FLORIDA POWER & LIGHT COMPANY
 ST. LUCIE PLANT
 1983-890 MW EXTENSION UNIT # 2
 GENERAL ARRANGEMENT
 REACTOR AUXILIARY BUILDING
 PLAN SHEET I

| DRY MECH | <i>[Signature]</i> | 2998-G-069 |
| DR/CHIN | | 16 |

PLAN AT EL. -0.50'

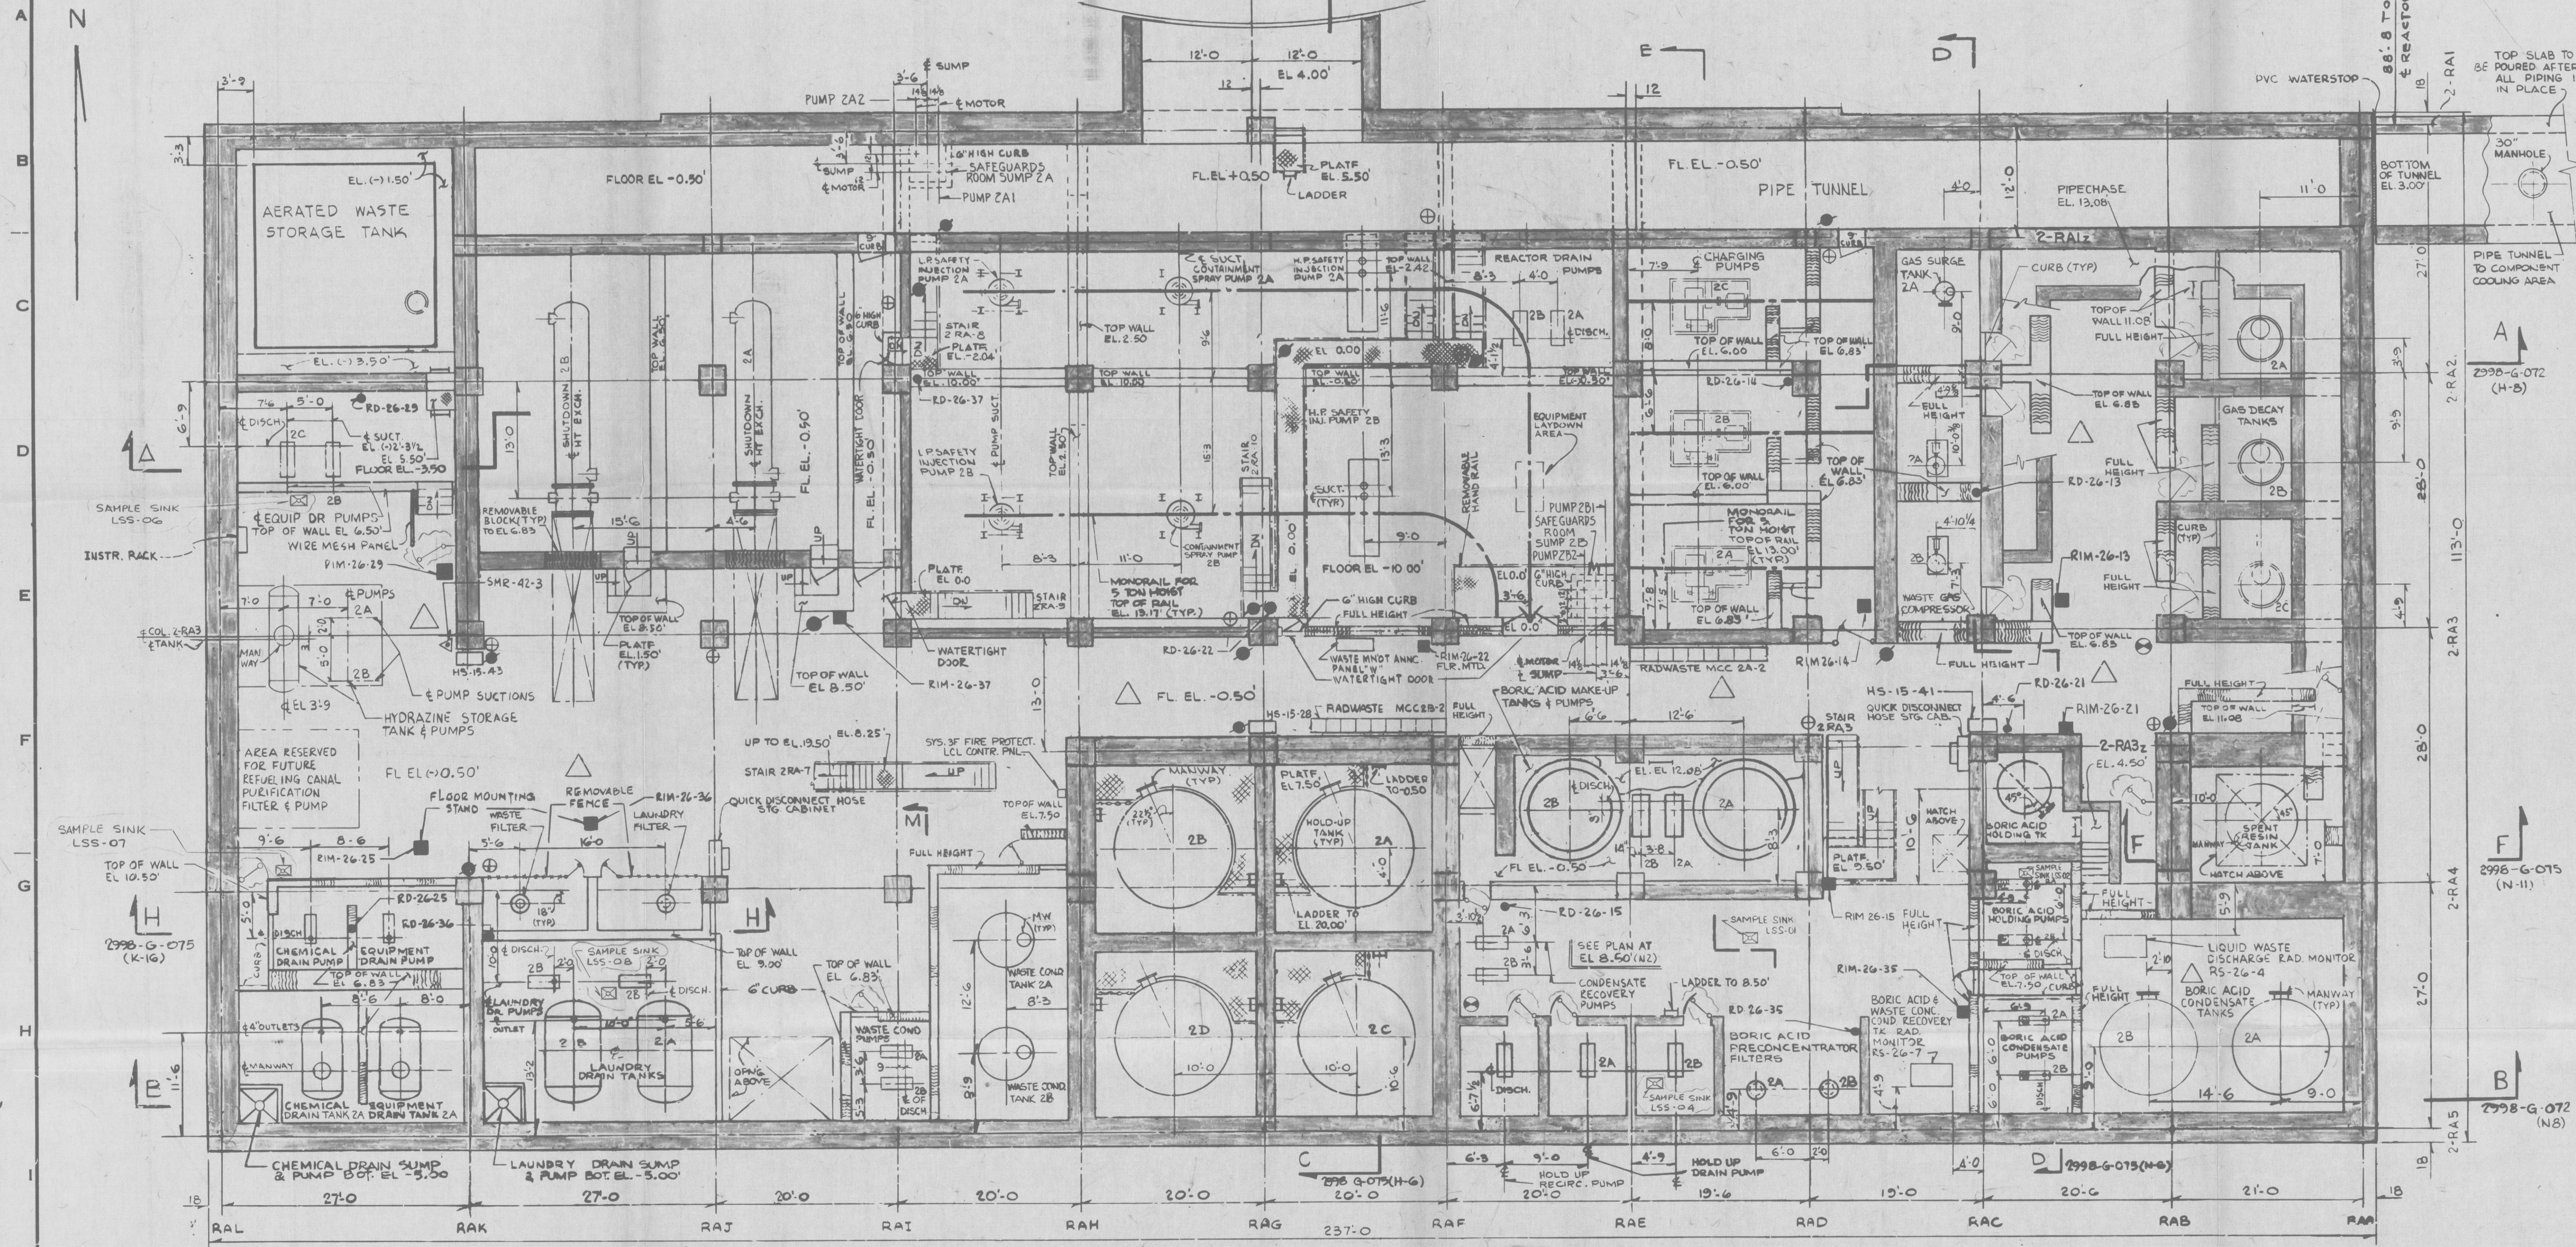
| NO | DATE | DESCRIPTION | BY | CHK | APPROVED |
|----|----------|---|------|-----|----------|
| | | PC/M 073-283 | | | |
| | | ADD (D1, 47, H4, 11) SAMPLE SINK. | | | |
| | | GENERAL REVISIONS (D1, C15, E15, E15H10, H1) GATES AND DOORS; ADD (G2, G4, H6, G10) GATES. | | | |
